UNITED STATES PATENT AND TRADEMARK OFFICE

10/582,466

Office Action Summary	Application No. 10/582,466	Applicant(s) KRAEUTLER, BERNARD	
	Examiner PHILIP S. KWON	Art Unit 3634

DETAILED ACTION

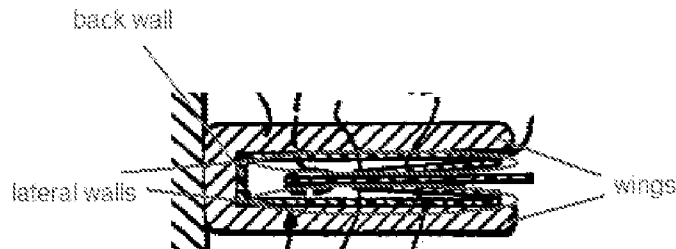
[Claim 1] As best understood by the examiner ... Murray discloses a door (Fig. 1 – although Murray states that he has a window, it also fits the definition of a door, which is provided above. If a door and window are not held to be included by the above definition, then the window would be an obvious alternative) comprising:

two lateral posts (10 – Col. 2, lines 41-45; post 10 on each side) each having a slideway (11') bounded by two wings (see above),

a transverse element (2) connecting upper ends of the lateral posts;

a flexible curtain (3) having lateral edges engaging in each of the slideways; and

wherein each of the slideways is equipped with a sealing profile having a back wall (Fig. 5) and two lateral walls (15') substantially forming a U-shape, each of the respective lateral walls bearing against the respective wing against which it is adjacent to.

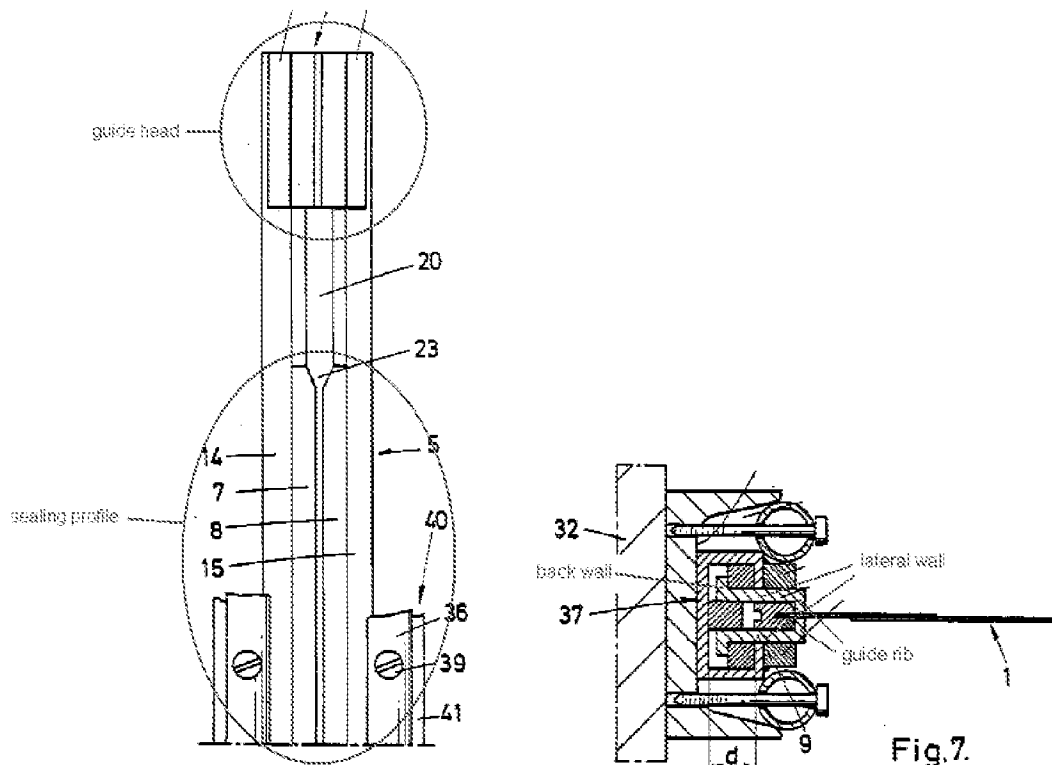
Chigusa teaches a sealing profile (Fig. 2) wherein each lateral wall is provided with at least one lip (8) which is able to come into contact with a lateral edge of the curtain.

[Claim 5] Murray in view of Simon and Chigusa discloses wherein each of the lateral walls and each lip are tapered at their ends (Murray - Fig. 5; Chigusa - Fig. 2).
